**Environmental
Planning
Commission**

**Agenda Number: 04
Project #: 2018-001198
RZ-2018-00062, SI-2018-00283
Hearing Date: February 14, 2019**

Staff Report

Agent	Consensus Planning, Inc
Applicant	PV Trails Albuquerque, LLC
Request	Zone Map Amendment (Zone Change) and Site Plan - EPC
Legal Description	All or a portion of Tract 1 and Tract 2, Bulk Land Plat of The Trails, Unit 3A
Location	On Woodmont Ave. NW, between Paseo del Norte NW and Major Public Open Space
Size	Approximately 20.5 acres
Existing Zoning	R-1B and R-ML
Proposed Zoning	R-ML and R-1B

LANDSCAPE CONCEPT

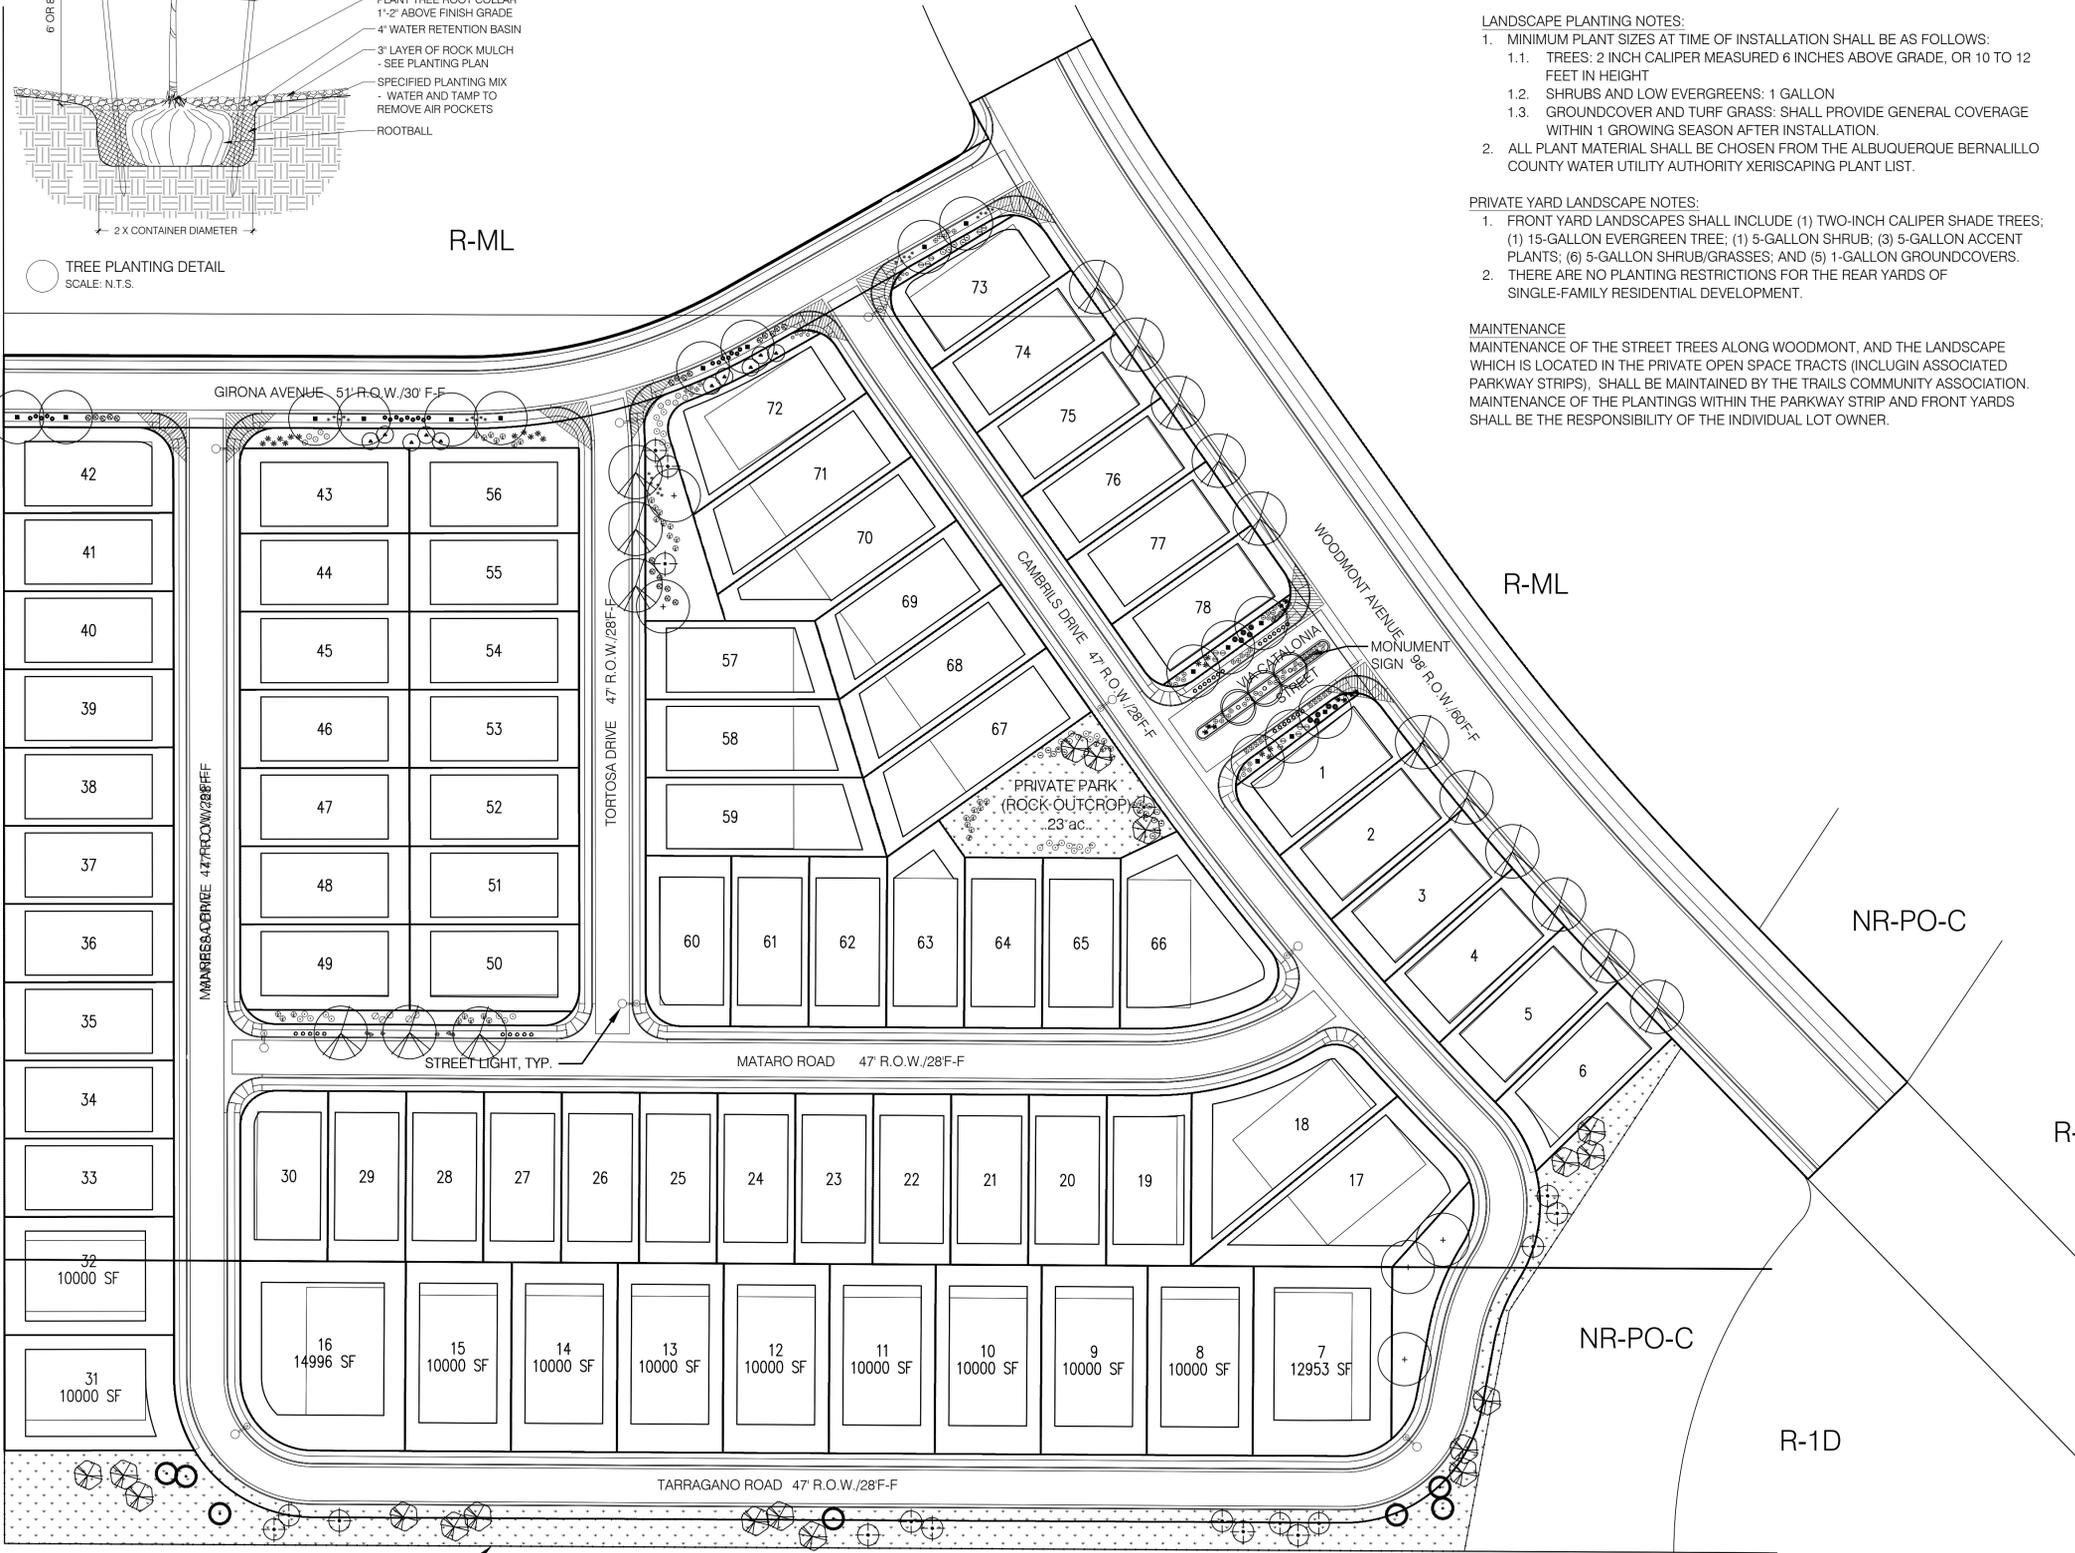
- **SOLID WASTE MANAGEMENT DEPARTMENT**
 - Do not plant anything that will create an overhang for refuse truck access/exit-Sheet #2 (Landscape Plan).
 - **ABC WATER UTILITY AUTHORITY (ABCWUA)**

Do not plant anything that will create an overhang for refuse truck access/exit-Sheet #2 (Landscape Plan).
